ADDENDUM NO. 2

DATED: SEPTEMBER 30, 2026

PROJECT: **REBID**
New Fleet Management Building for AIDT
Montgomery, Alabama

PH&J No: 2502-CUA

1 FLOOR PLAN - AUXILIARY POWER
E4.1 SCALE: 1/8"=1'-0"

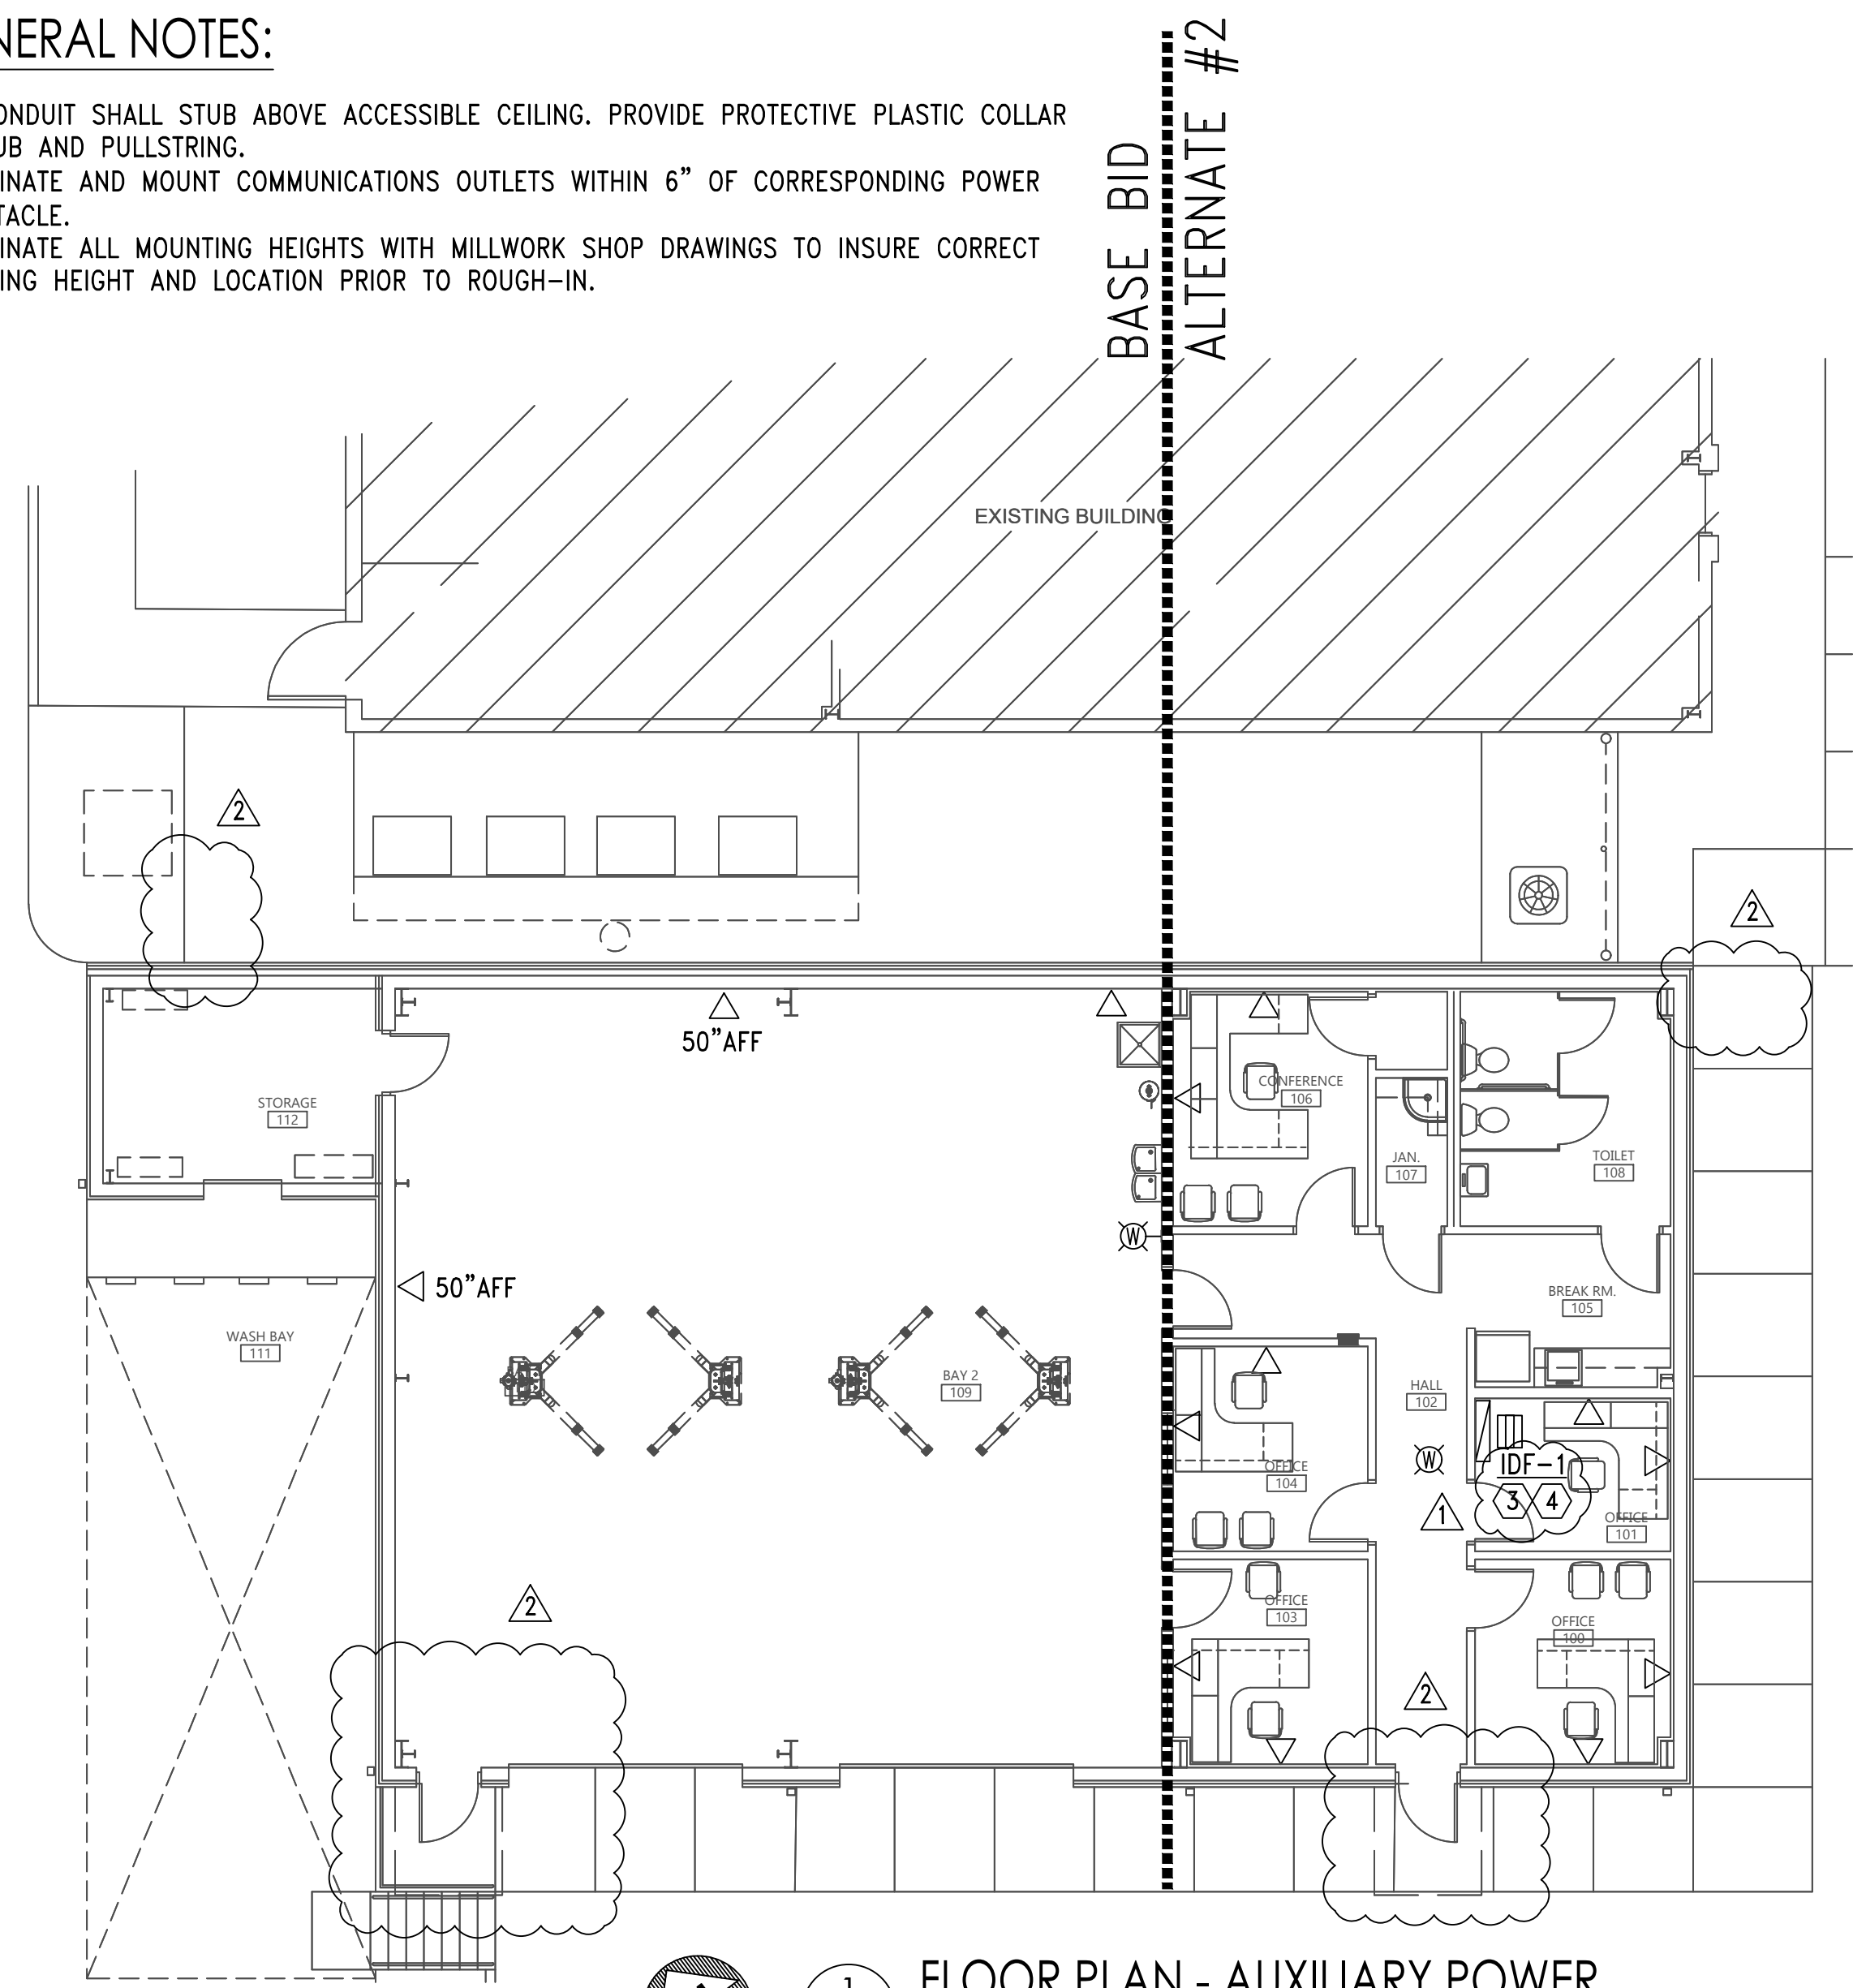
3. **Auxiliary Power Plan** (Sht. E4.1): See **Attachment #6** for deletion of electric door locks, card readers and cameras.
